ATTACHMENT 2 TO NL-13-123

RESPONSE TO REQUEST FOR ADDITIONAL INFORMATION
REGARDING P-T LIMITS AND LTOP REQUIREMENTS
VESSELS AND INTERNALS INTEGRITY BRANCH (EVIB)
(Non-proprietary version)

ENTERGY NUCLEAR OPERATIONS, INC.
INDIAN POINT NUCLEAR GENERATING UNIT NO. 2
DOCKET NO. 50-247

Response To Request For Additional Information

Figure 1: Comparison of IP2 WCAP-16752-NP P-T Limits to Inlet Nozzle Limits

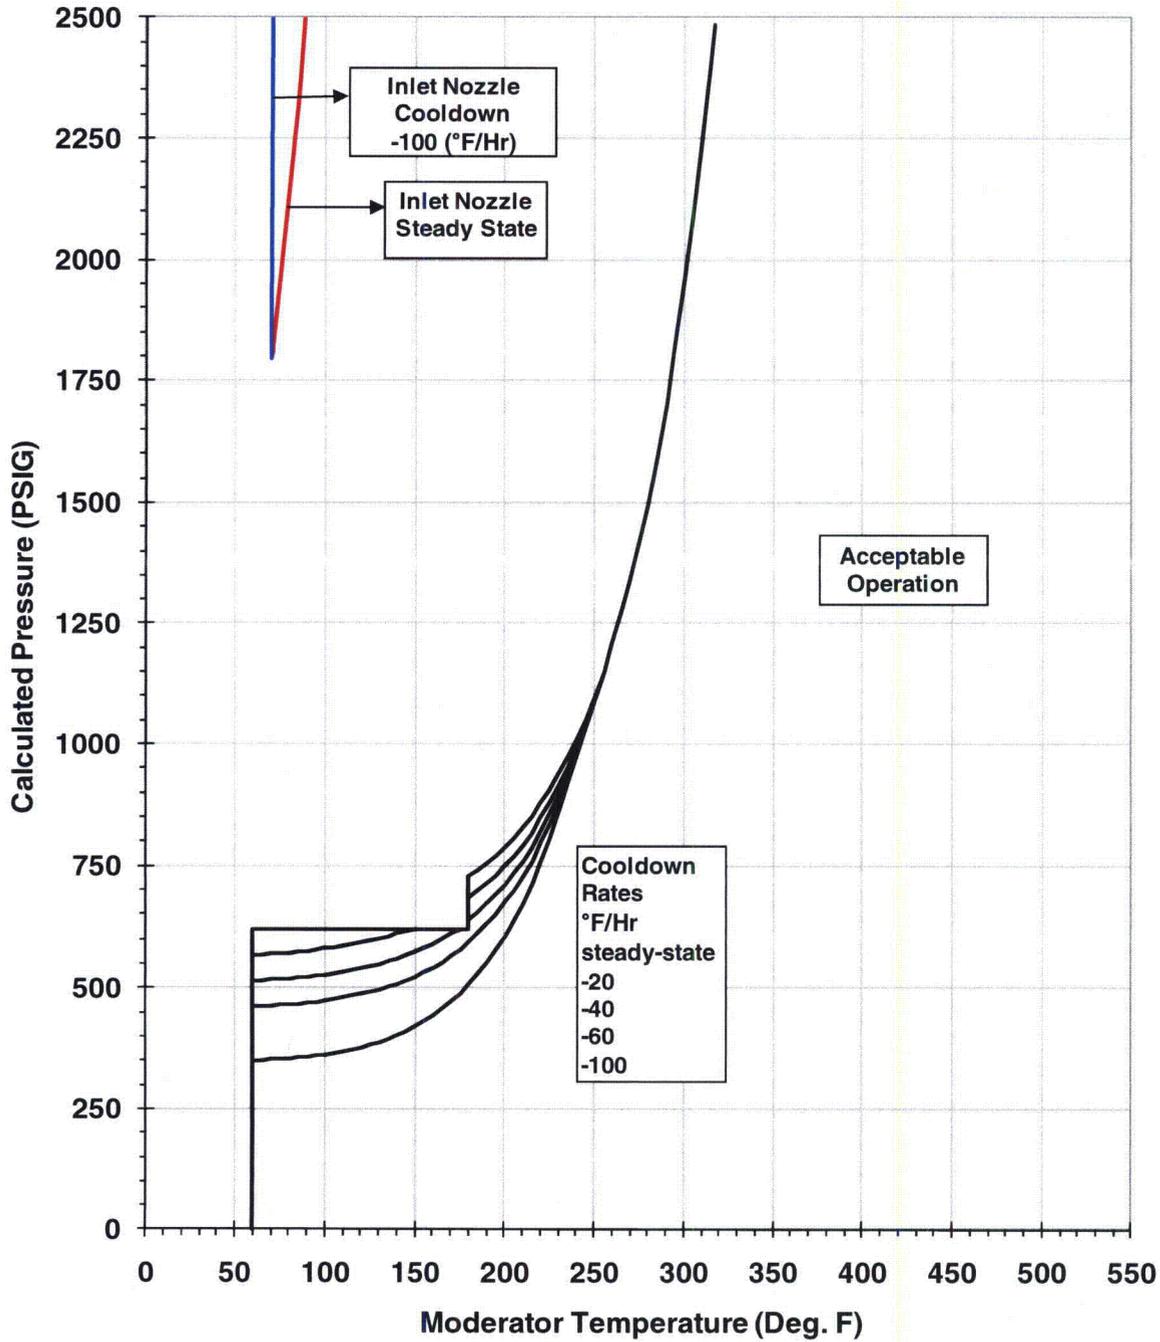
Consequently, please describe how the P-T limit curves submitted for IP2, and the methodology used to develop these curves, considered all RV materials (beltline and non-beltline) and the lowest service temperature of all ferritic RCPB materials, consistent with the requirements of 10 CFR Part 50, Appendix G.

The Indian Point Unit 2 inlet and outlet nozzle P-T limit curves are shown in Figures 1 and 2, respectively, based on the stress intensity factor expression discussed above; also shown in these figures are the traditional beltline P-T limits from WCAP-16752-NP. The nozzle P-T limits are provided for a cooldown rate of -100°F/hr, along with a steady-state curve.

Based on the results shown in Figures 1 and 2, it is concluded that the nozzle P-T limits are bounded by the traditional beltline curves. Therefore, the P-T limits provided in WCAP-16752-NP for 48 EFPY are still applicable for the beltline and non-beltline reactor vessel components.
